# City of San Antonio

Re: The Orchard

**MDP # 002-11**

**THE ORCHARD**  
SAN ANTONIO, TEXAS  
**MASTER DEVELOPMENT PLAN**

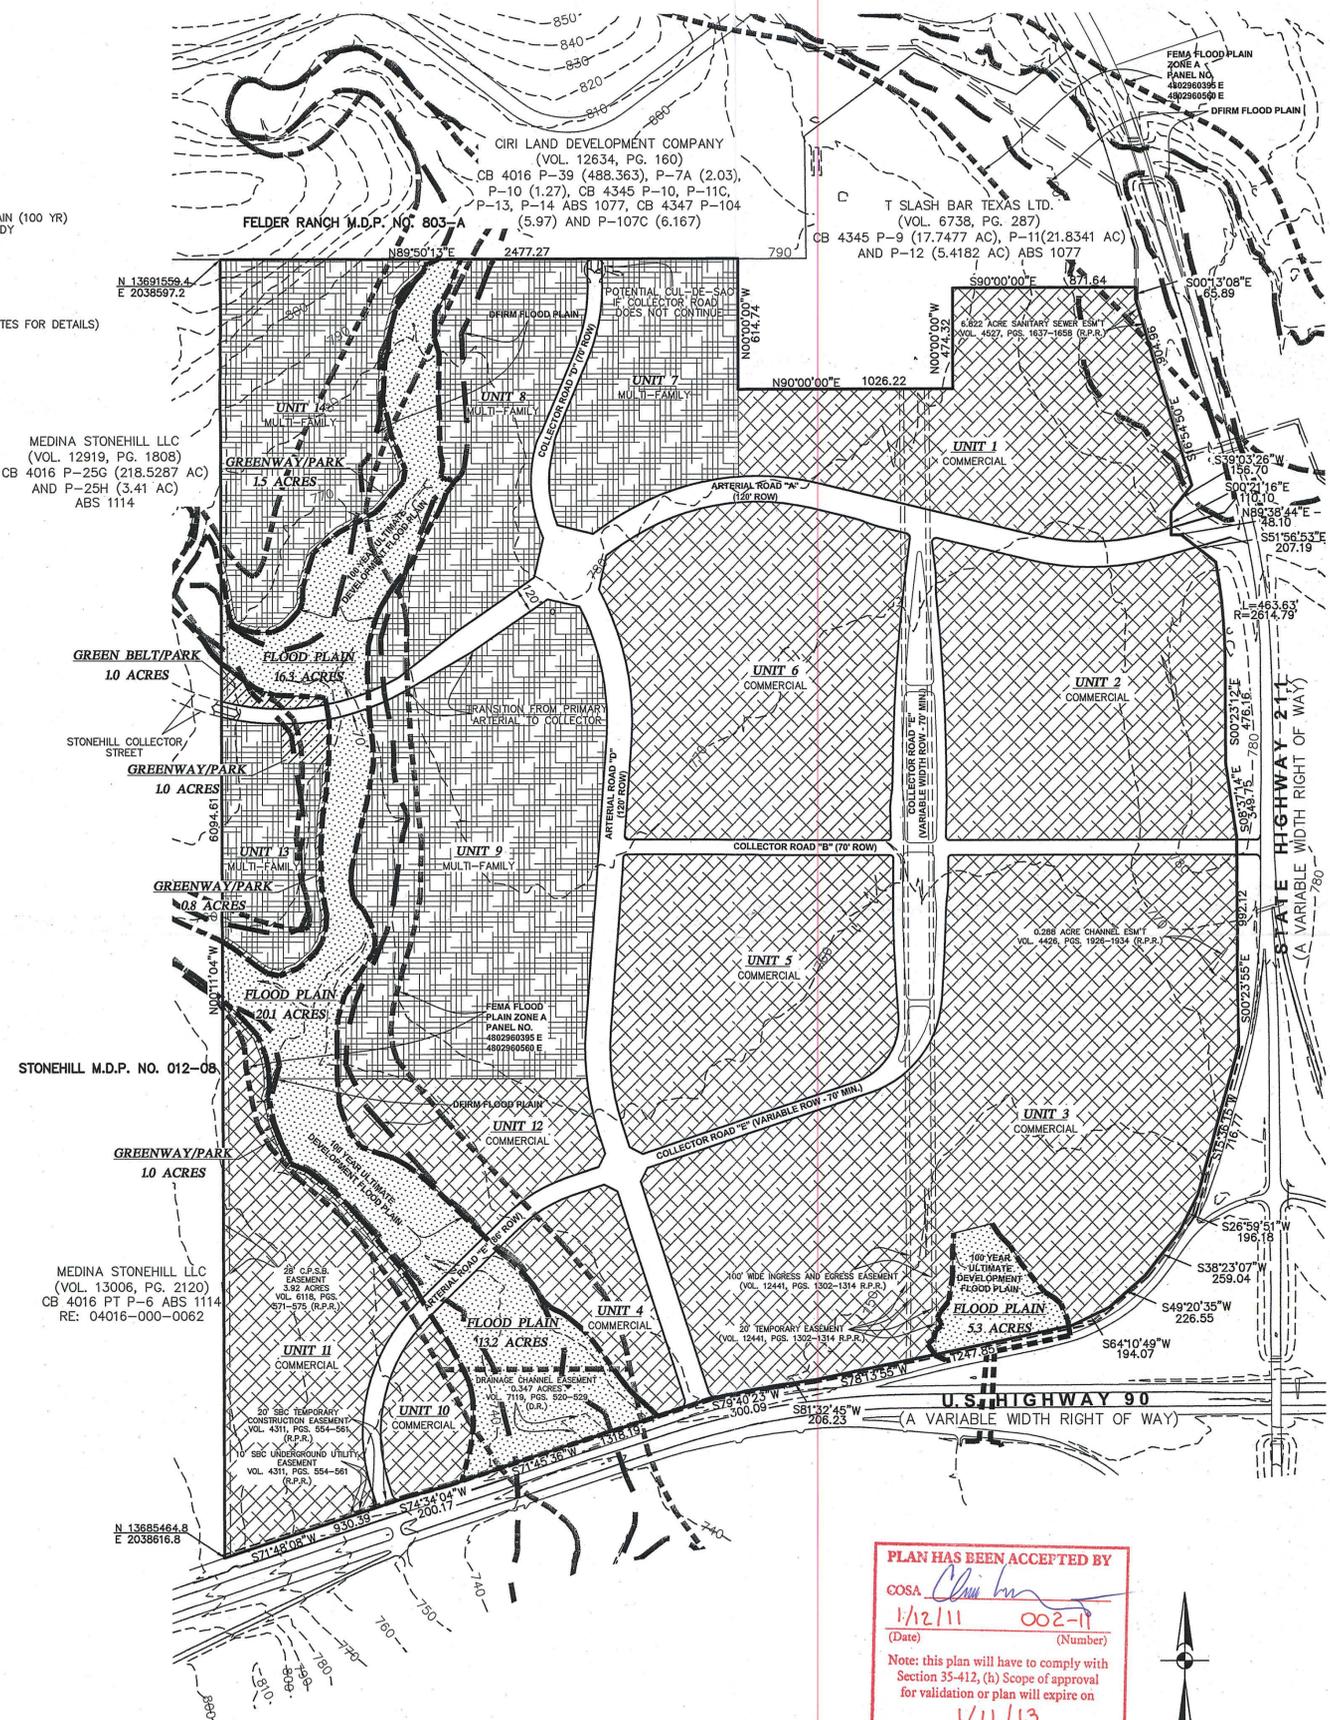
The Development Review Committee has evaluated **The Orchard** Master Development Plan, or **MDP # 002-11**. Enclosed is an accepted and signed copy of the MDP for your files. However, please note the following conditions:

It will be expected that all of the property depicted in the Master Development Plan including but not limited to floodplains, drainage areas, and open space shall be platted. All platting shall comply with the Unified Development Code (UDC), the City's Master Plan, Major Thoroughfare Plan, and all applicable regulations for the City of San Antonio.

Please note that this action by the committee does not establish any commitment for the provision of drainage, utilities, services or zoning of any type now or in the future by the City of San Antonio. In addition, it is suggested to work closely with the school district, so they can plan for the development accordingly.
